Access Compliance Report Public Rights-of-Way (Curb Ramps)

Main Street: OAKVALE_DR Cross Street: FAIRLYNN_BLVD Location: SE

ADA ID: RPAT210923102713 Ramp Type: Type 4 - Parallel Initial Pass/Fail: Fail Overall Compliance: No Severity Score: 15

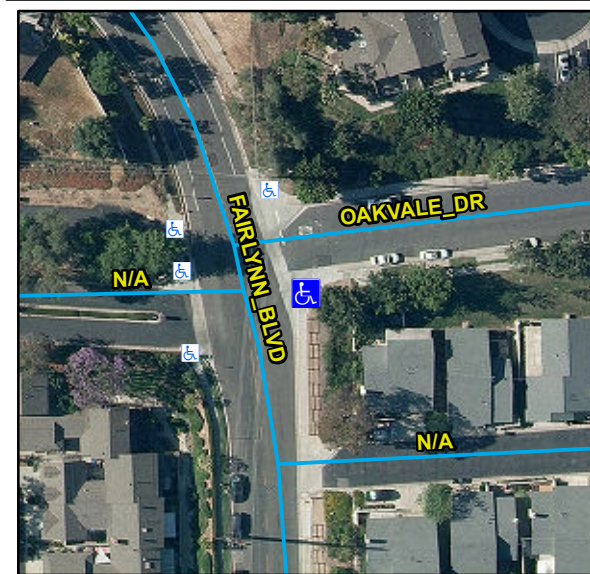
Compliance	Description	Data	Compliance	Description	Data
N/A	Ramp Length LT (in)	121	N/A	Ramp Length RT (in)	82
Yes	Ramp Width LT (in)	51	Yes	Ramp Width RT (in)	53
No	Ramp Run Slope LT (%)	10.9	Yes	Ramp Run Slope RT (%)	2.2
Yes	Ramp Cross Slope LT (%)	1.3	Yes	Ramp Cross Slope RT (%)	0.5
N/A	Landing Present	N/A	N/A	DWS Provided	N/A
N/A	Landing Length (in)	N/A	N/A	DWS Contrast	N/A
N/A	Landing Width (in)	N/A	N/A	DWS Length (in)	N/A
N/A	Landing Run Slope (%)	N/A	N/A	DWS Full Width	N/A
N/A	Landing Cross Slope (%)	N/A		DWS Offset Type	N/A
N/A	Landing Movement Obstructed?	N/A	N/A	DWS Offset Left (in)	N/A
	Landing Movement Type	N/A	N/A	DWS Offset Right (in)	N/A
N/A	Landing Shared	N/A			
N/A	Clear Space	Yes			
N/A	Clear Space To Crosswalk (in)	N/A			
N/A	Marked Crosswalk 1	No	N/A	Marked Crosswalk 2	No
	Crossing 1 Direction	N		Crossing 2 Direction	W
	Marked Crosswalk 1 Width (in)	N/A		Marked Crosswalk 2 Width (in)	N/A

Possible Solutions:
Remove & Replace Curb Ramp With Two New Directional Ramps or Equivalent.

OC Std/PROW:
R304.3.2, STD 1115
